Landscape & Visual Impact Assessment Addendum

**Land North of Barlestone Road, Newbold Verdon,
Leicestershire**

Date: 21/03/2025 | Pegasus Ref: P22-3085

CLIENT: Hinckley and Bosworth Council
SITE: Land off Barlestone Road, Newbold Verdon
PURPOSE: Review of LVIA and landscape proposals
DATE: 30th January 2025

BARLESTONE ROAD, NEWBOLD VERDON - LANDSCAPE STRATEGY PLAN

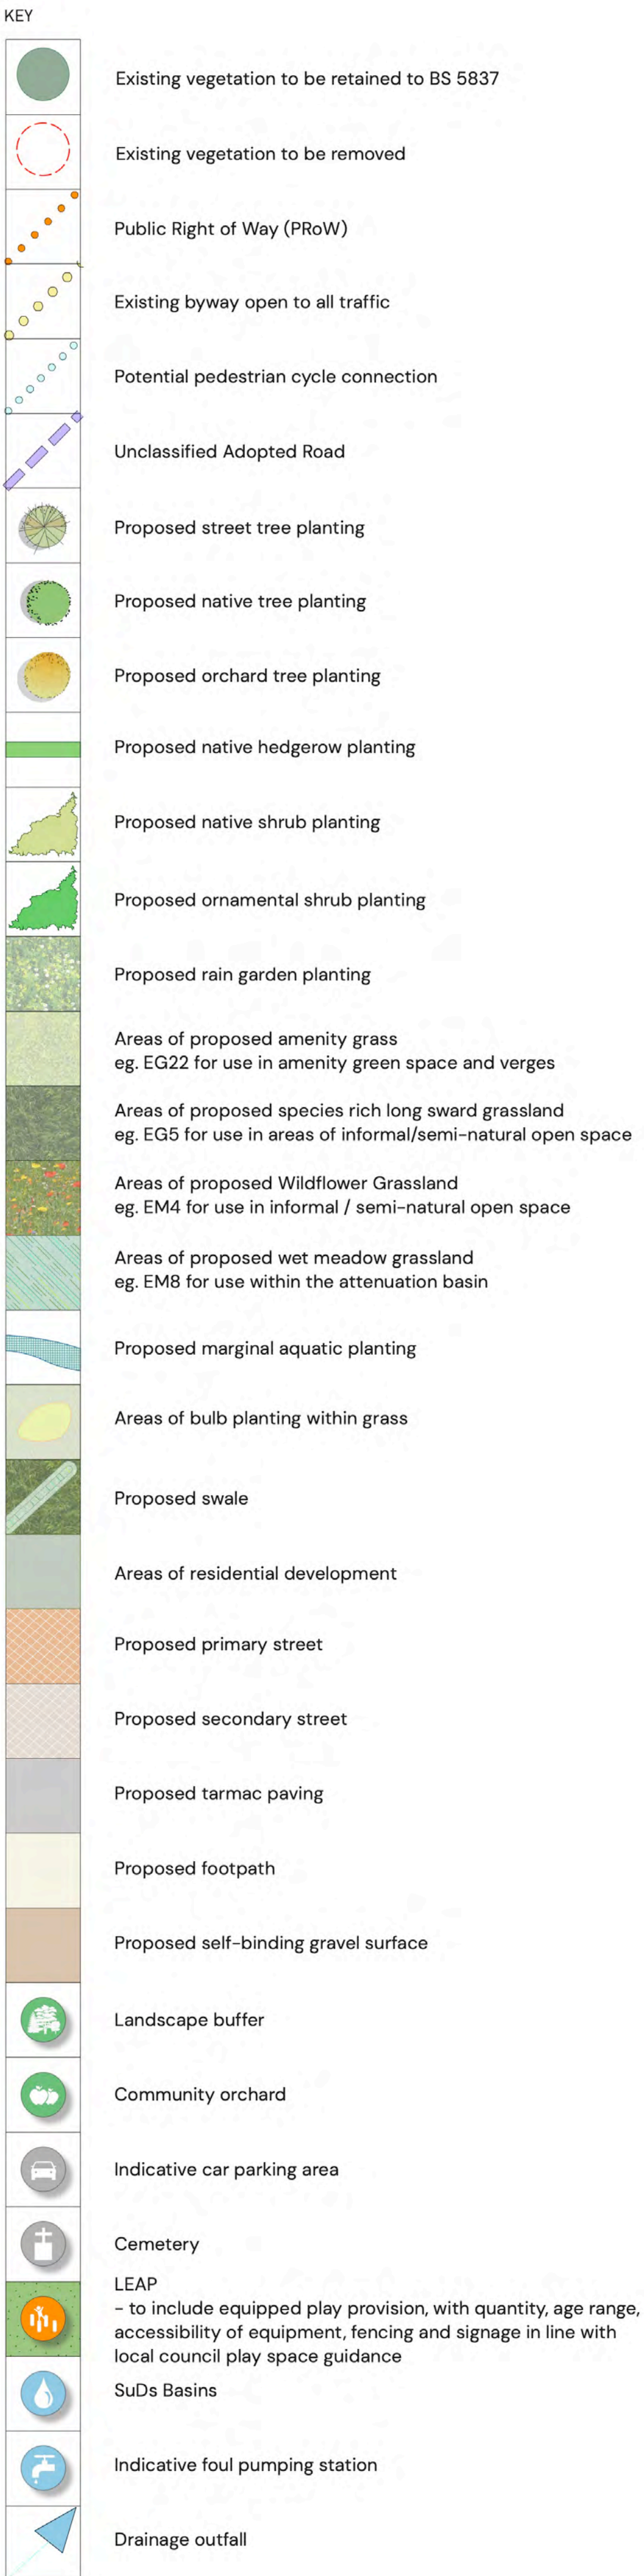
In relation to viewpoints 13, 14, I agree with the year 1 impacts of **major/ moderate adverse** but disagree that the mitigation proposed will be enough to reduce to **moderate adverse** effects by year 15. Additional buffer planting on the eastern edge would help to reduce visual impacts. This could be done either within the site or as a landscape buffer to the east of the existing red line to minimise visual impacts from the public right of way to the east of the site.

- i) The layout creates a series of secure perimeter blocks overlooking open space provision and buffer planting
- ii) The retention of majority of hedgerows apart from access location is good to see.
- iii) The layout provides a good landscape buffer to the north of the site.
- iv) The buffer planting to the east of the site is weak.
- v) Despite creating a green corridor down the public right of way that cuts diagonally across the site residential development will still be visible and the road that cuts across the PRow will affect its character
- vi) The north south lane/ public right of way passing through the middle of the site has limited buffer planting and residential is still likely to be visible along this route.
- vii) The creation of new triangular landscape spaces and additional tree planting is positive.

- 9) The buffer planting to the east of the site is weak and the buffer to the north south public right of way could be strengthened.

- Further mitigation for Viewpoints 13 and 14 – east of the Site. The landscape buffer to the eastern boundary has been increased to up to 15m in width and strengthened to include retention and enhancement of the existing hedgerow together with increased tree and shrub planting;
- The inclusion of a half size MUGA and relocation of the equipped play space within the layout;
- Relocation of SuDS to the northwest of the site and remodelling of the residential layout.
- Amendments to the road frontage hedgerow proposals in light of losses resulting from the access visibility splays.

3.3. Following these amendments, an updated Indicative Masterplan (Drawing Ref. P22-3085_DE_O13_R_O1) and Indicative Landscape Strategy Plan (drawing Ref. P22-3085_EN_O17F) have been prepared and are included at Appendix 2.

P22-3085_EN_017_01

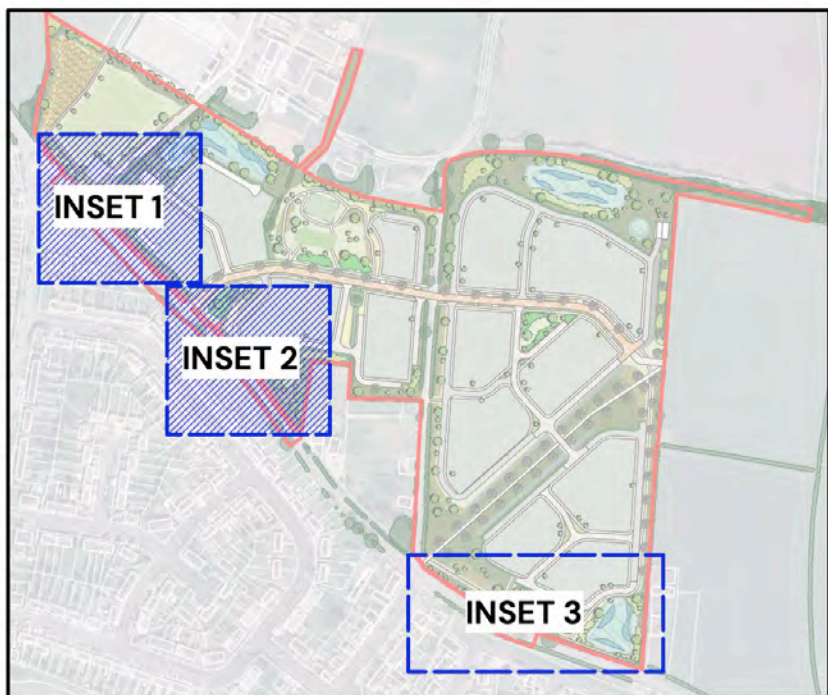
- 2.13. In addition to Node's comments the planning case officer raised some queries about the extent of the Barlestone Road hedgerow, which is proposed to be retained, given the extent of the proposed access visibility splays, and whether 2 Category B trees within the visibility splays could be retained.
- 2.14. In response to these queries, it can be confirmed that the 2 Category B trees shown on the plan within the visibility splays can be retained and, where hedgerow losses are to occur along the Barlestone Road frontage, these will be compensated for with new lengths of native hedgerow planting set back behind the splays. To clarify the extent of retention and loss, together with the extent of new planting, two additional

drawings, based on the Indicative Landscape Strategy Plan have been prepared (Drawing Refs. P22-3085_EN_O17_O1 and P22-3085_EN_O17_O2) and are included at Appendix 3.
